**NORTH BEACH WATER DISTRICT
PACIFIC COUNTY, WASHINGTON
RESOLUTION NO. 05-2014**

**A RESOLUTION OF THE BOARD OF
COMMISSIONERS OF NORTH BEACH WATER
DISTRICT, PACIFIC COUNTY, WASHINGTON,
ACCEPTING CHANGE ORDER NUMBER ONE TO
DWSRF PROJECT DML2-952-121 CONTRACT**

CHANGE ORDER

Project Title	Water Main Project		
Owner	North Beach Water District	Contractor Name	Big River Excavating
Change Order No.	1	Contractor Address	1050 Olney Avenue Astoria, OR 97103
Change Order Date	January 30, 2014		
G&O No.	13223.00

JOB NO.: 1323100 SHEET: C-1SR OF: 15	NORTH BEACH WATER DISTRICT PACIFIC COUNTY WASHINGTON WATER MAIN PROJECT BORING DETAILS		CHANGE ORDER PROPOSAL	1/14	MBJ	DATE: JAN 2014	 CONSULTING ENGINEERS 2702 CARRIAGE DRIVE SW, BLDG. 1 OLYMPIA, WASHINGTON 98502 • (360) 292-7481
			No.	REVISION	DATE	APPD

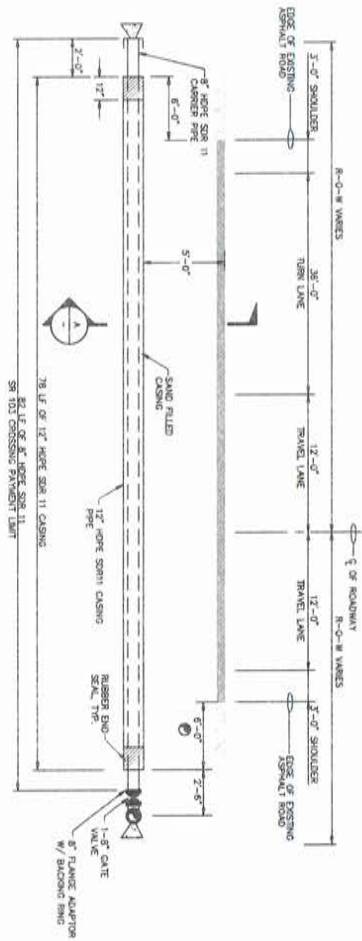
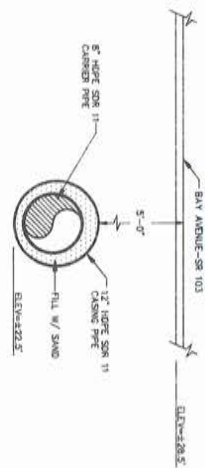
The additional work consists of constructing approximately 210 linear feet of 8-inch water main, and approximately 80 linear feet of 12-inch HDPE casing, under SR103 at "Z" Street. Approximately 80 linear feet of the 8-inch water main shall be directionally drilled beneath State Route 103- Bay Avenue. All surfaces disturbed by construction activities shall be restored. All work shall be completed in accordance with the revised Plans C-8R and C-15R.
